Access Compliance Report Public Rights-of-Way (Curb Ramps)

Main Street: ABYSSINIAN_WAY		Cross Street: CLYDESDALE_DR		Location:	SE
ADA ID: RPRK211110134639	Ramp Type: Type 4 - Parallel	Initial Pass/Fail: Fail	Overall Compliance: No	Severity Score:	2
Codes/Mitigation Info/Possible Solution			Field Measurements/Component Compliance

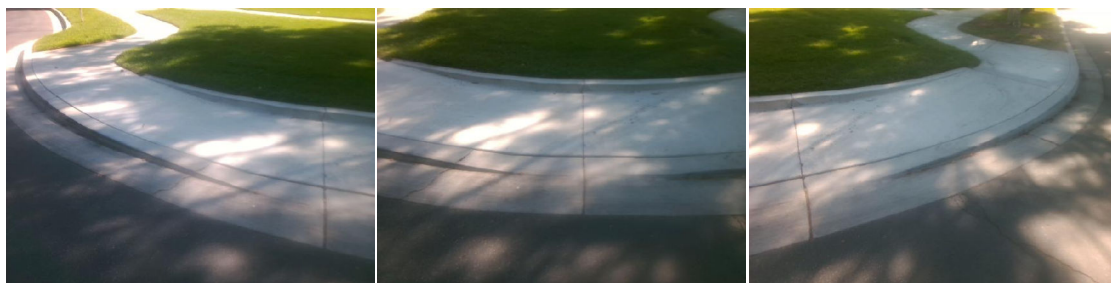
Compliance	Description	Data	Compliance	Description	Data
N/A	Ramp Length LT (in)	131	N/A	Ramp Length RT (in)	137
Yes	Ramp Width LT (in)	52	Yes	Ramp Width RT (in)	52
Yes	Ramp Run Slope LT (%)	4	Yes	Ramp Run Slope RT (%)	3.8
Yes	Ramp Cross Slope LT (%)	0.8	No	Ramp Cross Slope RT (%)	2.8
N/A	Landing Present	N/A	N/A	DWS Provided	N/A
N/A	Landing Length (in)	N/A	N/A	DWS Contrast	N/A
N/A	Landing Width (in)	N/A	N/A	DWS Length (in)	N/A
N/A	Landing Run Slope (%)	N/A	N/A	DWS Full Width	N/A
N/A	Landing Cross Slope (%)	N/A		DWS Offset Type	N/A
N/A	Landing Movement Obstructed?	N/A	N/A	DWS Offset Left (in)	N/A
	Landing Movement Type	N/A	N/A	DWS Offset Right (in)	N/A
N/A	Landing Shared	N/A			
N/A	Clear Space	Yes			
N/A	Clear Space To Crosswalk (in)	N/A			
N/A	Marked Crosswalk 1	No	N/A	Marked Crosswalk 2	No
	Crossing 1 Direction	N		Crossing 2 Direction	W
	Marked Crosswalk 1 Width (in)	N/A		Marked Crosswalk 2 Width (in)	N/A

N/A	Ramp Inside Crosswalk 1	N/A	N/A	Ramp Inside Crosswalk 2	N/A
	Crossing 1 Slope (%)	2.5		Crossing 2 Slope (%)	2.3
	Crossing 1 Cross Slope (%)	1.2		Crossing 2 Cross Slope (%)	2.8
N/A	Gutter Ponding	N/A	No	Curb Slope	9.7
Yes	Gutter Lip Height (in)	0		Road Run Slope (%)	1.6
N/A	Gutter Run Slope (%)	N/A		Road Cross Slope (%)	3.4
N/A	Gutter Cross Slope (%)	N/A	Yes	Perpendicular Joint Present	Yes
Yes	Overall Surface Condition	Acceptable			
	Cross Gutter Present?	No		Spandrel Present?	No
	Replace Cross Gutter?	N/A		Replace Spandrel?	N/A

Remove & Replace Curb Ramp With Two New Directional Ramps or Equivalent.

R304.2.2, R304.5.3, STD 1115
